**Verification and certification report form for
CDM project activities
(Version 03.0)**

Title and UNFCCC reference number of the project activity	Landfill Gas Recovery and Flaring Project in El Verde Landfill Leon UNFCCC ID: 3378
Scale of the project activity	<input checked="" type="checkbox"/> Large-scale <input type="checkbox"/> Small-scale
Version number of the verification and certification report	1.0
Completion date of the verification and certification report	22/04/2020
Monitoring period number and duration of this monitoring period	6 th MP (1 st MP of the 2 nd CP) 27/10/2017 – 31/12/2018 (including both days)
Version number of the monitoring report to which this report applies	7.0
Crediting period of the project activity corresponding to this monitoring period	27/10/2017 – 26/10/2024 (including both days)
Project participants	Promotora Ambiental S.A.B. de C.V. First Climate AG
Host Party	Mexico
Applied methodologies and standardized baselines	ACM0001: Flaring or use of landfill gas, version 18

"Landfill Gas Recovery and Flaring Project in the El Verde Landfill, Leon"

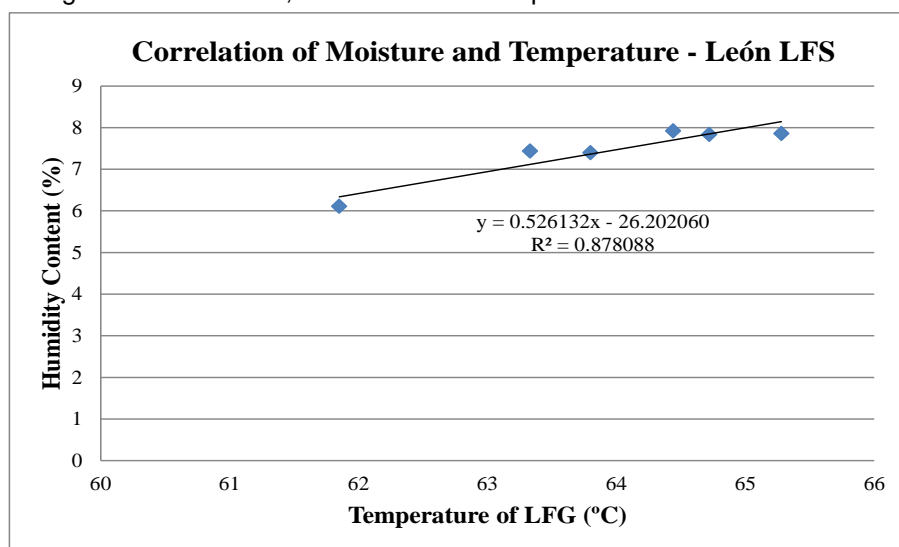
Project participant response				Date: 30/09/2019
<ol style="list-style-type: none"> 1) During the first crediting period, the CDM-PDD did not have any reference to the "Tool to determine the mass flow of a greenhouse gas in a gaseous stream" to correct the flow to dry basis when the temperature was greater than 60°C and there was not guidance to properly apply it. Moreover, considering that during the monitoring period no separate monitoring of temperature and pressure is necessary since the PP is using flowmeters that automatically express LFG volumes in normalized cubic meters, there is no measurement of the pressure of the gas to apply the Option 2 (Simplified calculation without measurement of the moisture content) of the "Tool to determine the mass flow of a GHG in a gaseous stream" version 3.0 Considering such situation, for the first submission of this monitoring period, rather than using the using equation (8) of the "Tool to determine the mass flow of a greenhouse gas in a gaseous stream" version 3.0, the PP hired the third party consultancy IECASA to measure the moisture content of the gas (vH₂O,t,db) as can be evidenced with the "Moisture Content Report_Leon_Feb-11". The experiment was conducted by artificially (i.e increasing the booster's suction) increasing the temperature of the gas above 60°C and measuring the moisture content of the gas to find a correlation between the temperature of the gas and its moisture content, as follows:

Temperature LFG (°C)	vH ₂ O,t,db (%)
63.33	7.429
61.85	6.103
64.44	7.916
64.72	7.828
63.80	7.389
65.28	7.852

Using the above values, the correlation was plotted as follows:

In the first submission of the current monitoring period, the PP corrected the monitored values of the parameter "VLFG,sent_flare,y,db" to dry basis for the cases when T exceeded the 60°C using the following correlation based on the data measured by IECASA in the "Moisture Content Report_Leon_Feb-11":
